# THE ILLUSION OF ENVIRONMENTAL PROTECTION

## PERMITTING LONGWALL COAL MINES IN PENNSYLVANIA

This report provides an in-depth, independent review of the Foundation Mine permit application and its review by the CDMO. This analysis provides a unique insight into the current regulatory review process involving longwall coal mines in Pennsylvania. It examines how well the current review process implements the laws and regulations adopted to protect environmental resources from coal extraction activities. This report uses the Foundation Mine application as a case study to determine how successfully the Pennsylvania Department of Environmental Protection requires an applicant to inventory resources at risk from a proposed longwall mine operation, predict potential impacts, and identify measures to minimize and address likely impacts in accordance with existing laws and regulatory requirements. The report also examines the adequacy and effectiveness of the State's mine permit application forms, technical guidance, and overall process in eliciting the information necessary to evaluate potential impacts and to demonstrate compliance with applicable laws and regulations.

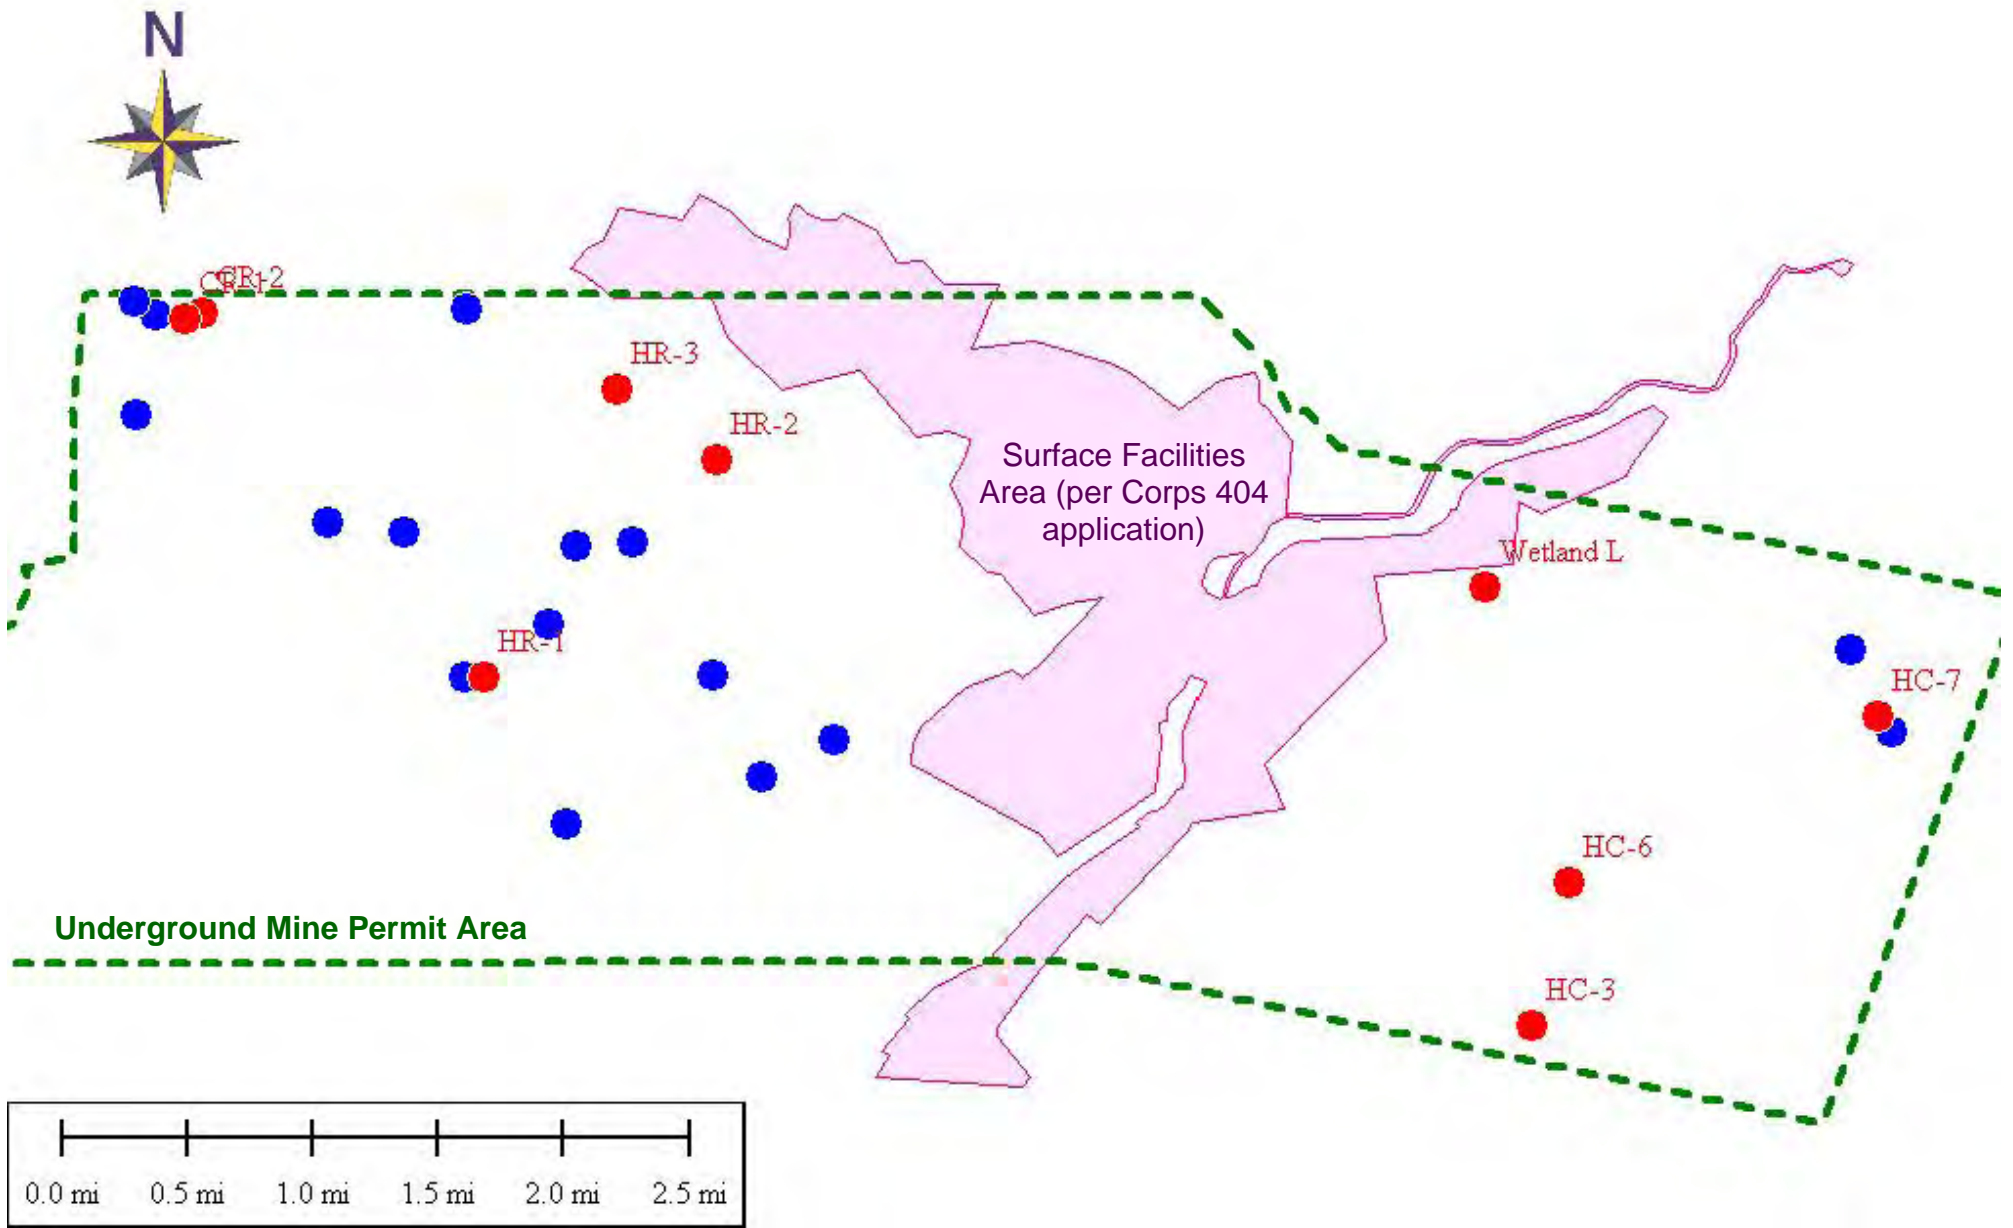
observed as well (**Figure 7**). Clearly, the CDMO was remiss in not seeking to confirm the accuracy of the wetland delineations outside of the surface activity areas as part of its review of the Foundation Mine permit application.

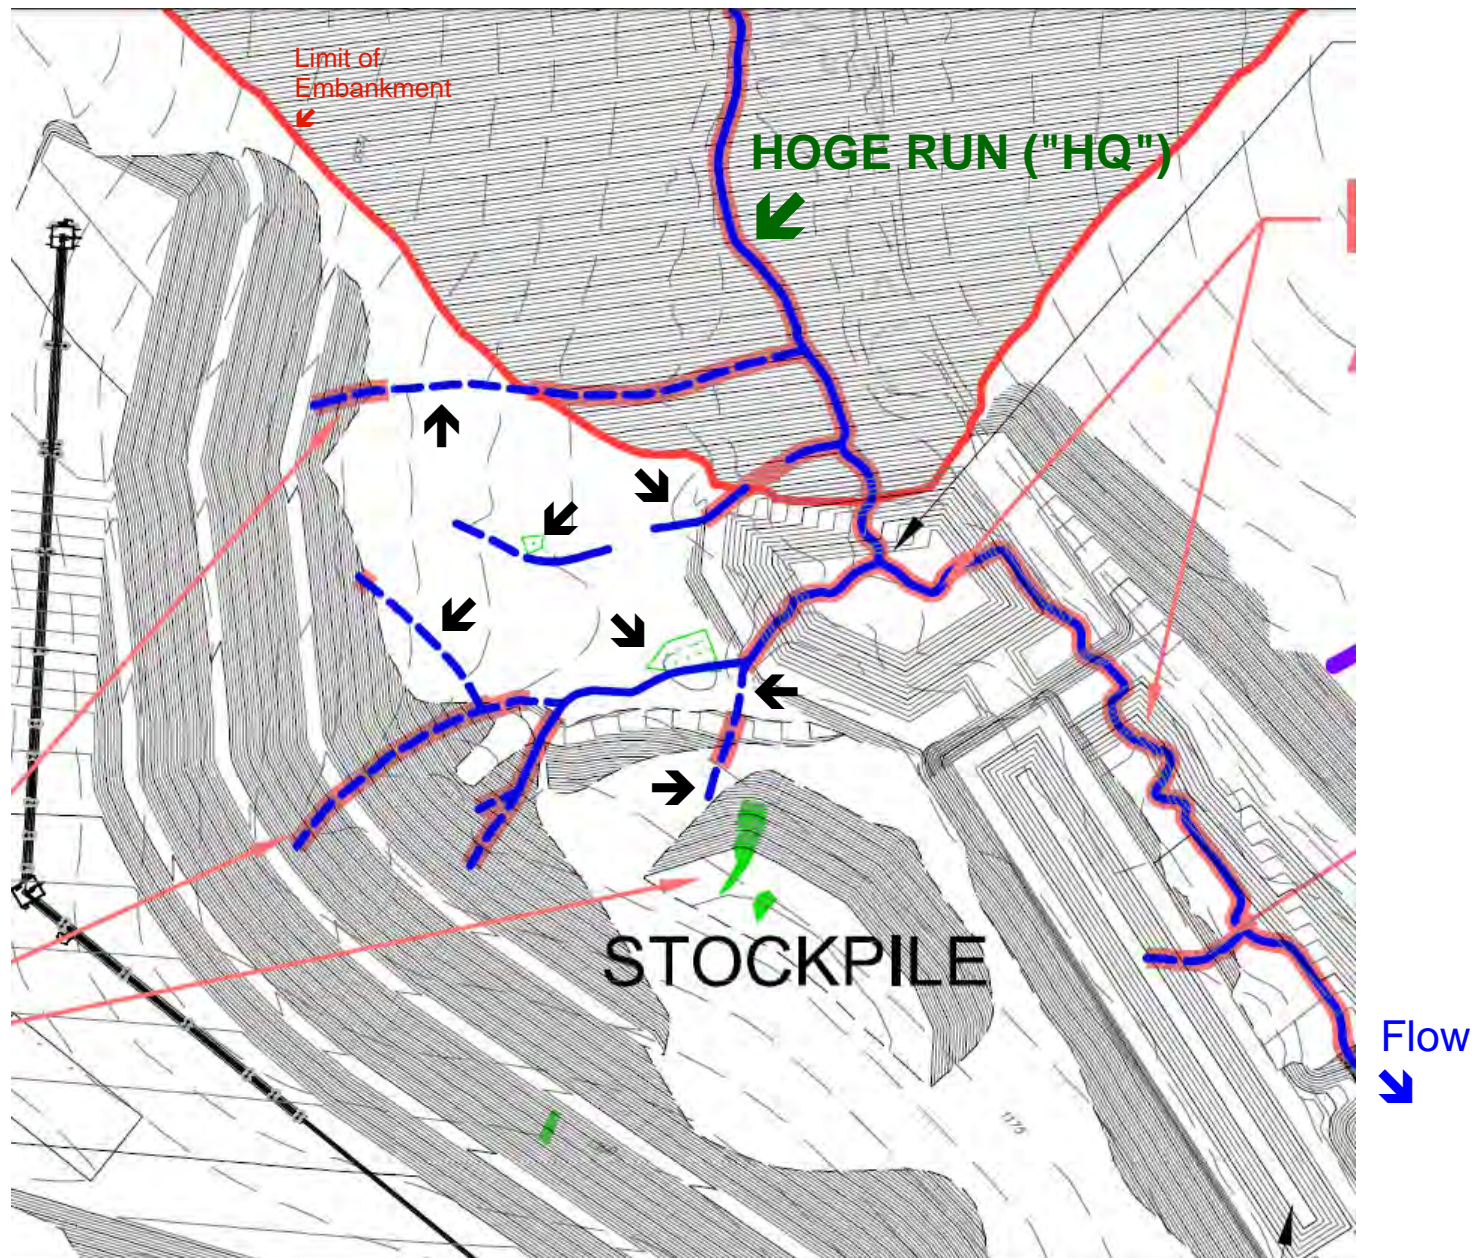
leaving these segments dramatically altered either in the headwaters or near the mouths of tributary streams. These orphaned segments (**Figure 8**) cannot and would not continue to function as “streams” once the virtual entirety of their watersheds was converted to industrial uses. The same was true in certain wetlands, where large sections of the wetland were to be directly impacted and the remaining section, with no chance of continued functioning, nevertheless was not counted as impacted.

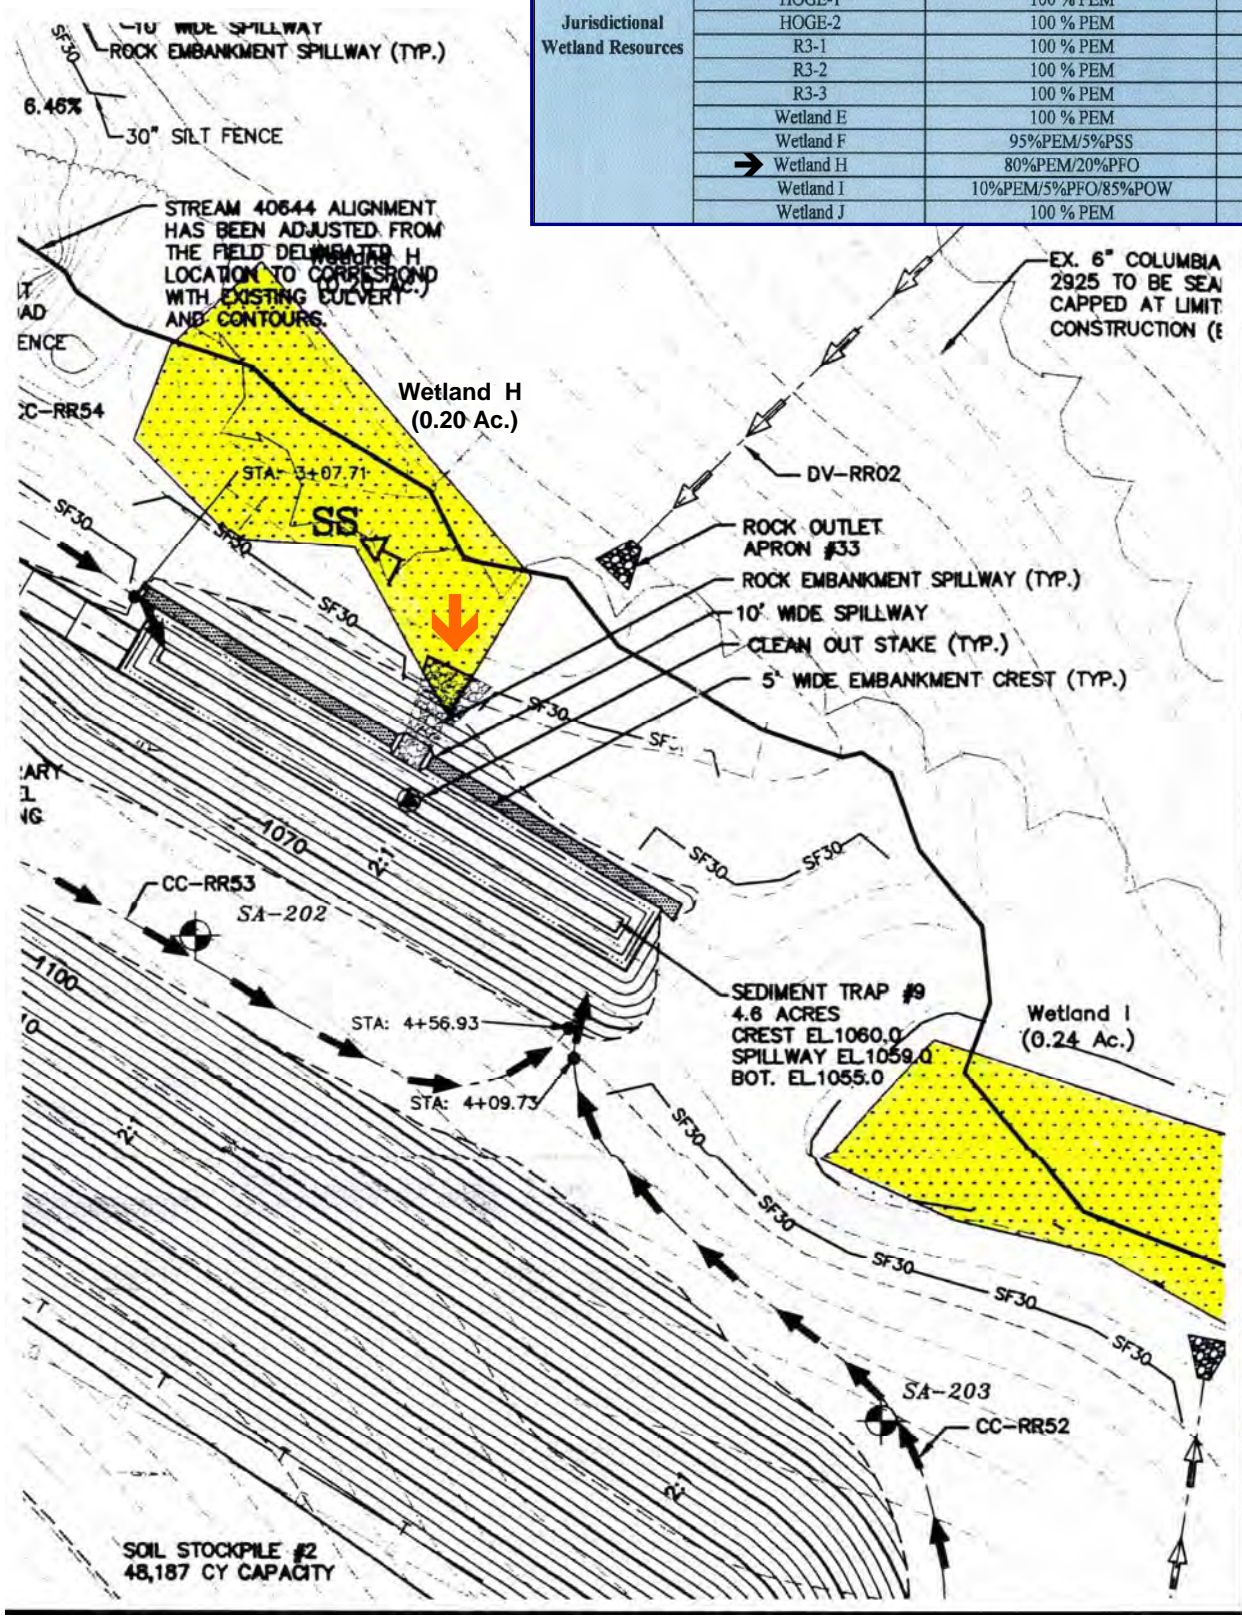
In some cases, even direct impacts were overlooked. For example, in the vicinity of the proposed Batch Weigh Loadout area, the rock outfall from a proposed sediment trap was shown on a drawing as extending into a corner of Wetland H (**Figure 9**). The footprint of that outfall, and any disturbance area around it necessary to install it, were not identified among the proposed wetland impacts anywhere in the State (or Corps) application.

Furthermore, in light of the significant amount of regrading proposed in the near vicinity of Wetland H, plus the proposed loss of the surrounding forest habitat, and the hydrologic disruptions proposed nearby (including the collection of sheet runoff and its redirection through manmade diversion ditches around proposed soil stockpiles), the hydrologic balance of all of Wetland H (as well as Wetland I just upstream from it) would be significantly impacted. Additionally, the Corps JD confirmed that Wetland H was 0.38 acre, or almost twice as large as was shown in the State coal mine application, so the actual direct and indirect impacts to it might be even larger than the 0.20 acre acknowledged in the 2010 application.
